# Addendum

## Instructions for Converting Honeywell Valve Part No. VR8205S 2288 to LP/Propane Gas.

Figure 1

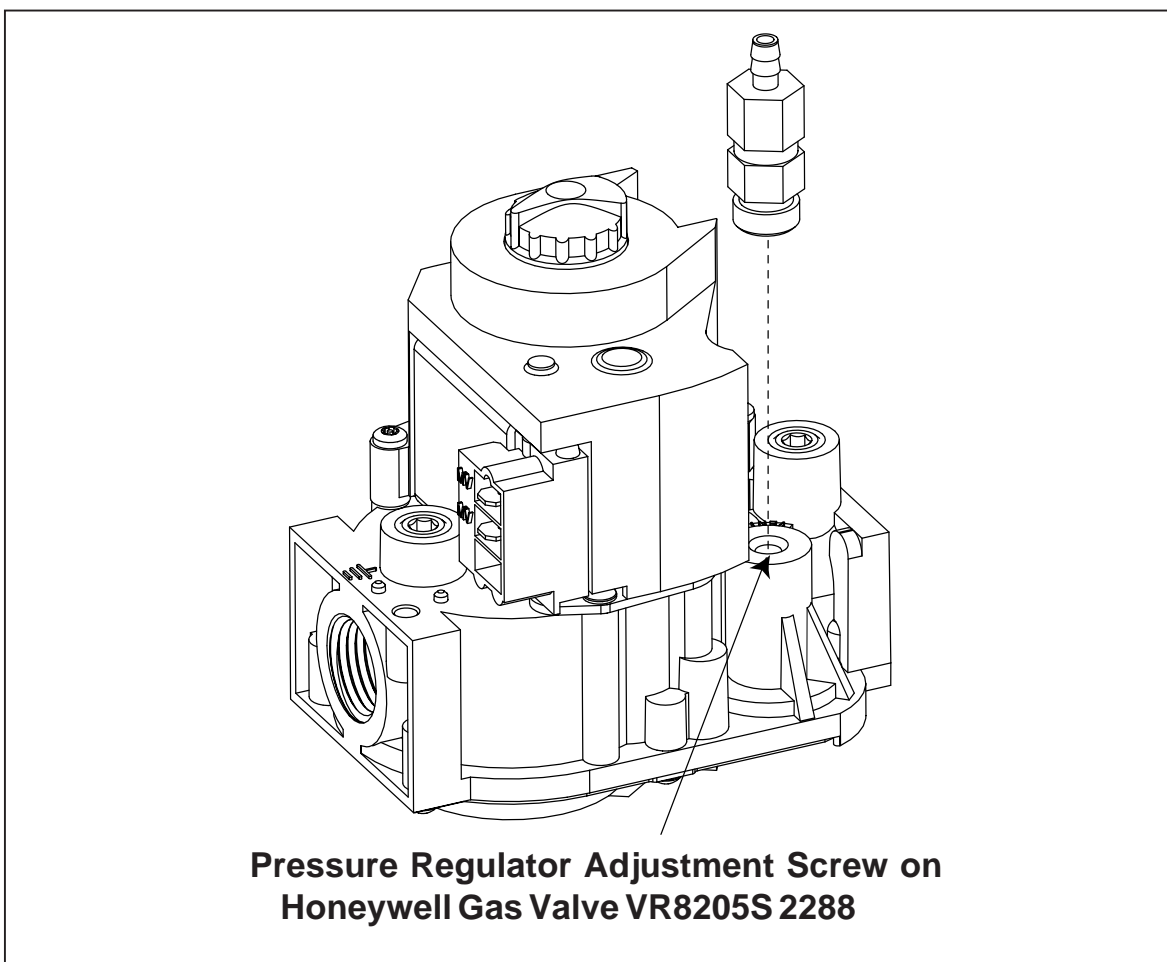
1. Turn off gas supply at the appliance service valve.
2. When converting this valve, use conversion kit part number 624642 ONLY.
3. Remove the pressure regulator adjustment screw located underneath the cap screw. For condensing furnaces, the Pressure Regulator Adjustment is located underneath the brass fitting (see Figure 1).
4. Remove the existing spring.
5. Insert the replacement spring.
6. Reinstall the plastic pressure regulator adjustment screw.
7. Check and adjust the regulator setting using a manometer.
8. Continue conversion per manufacturers instructions.
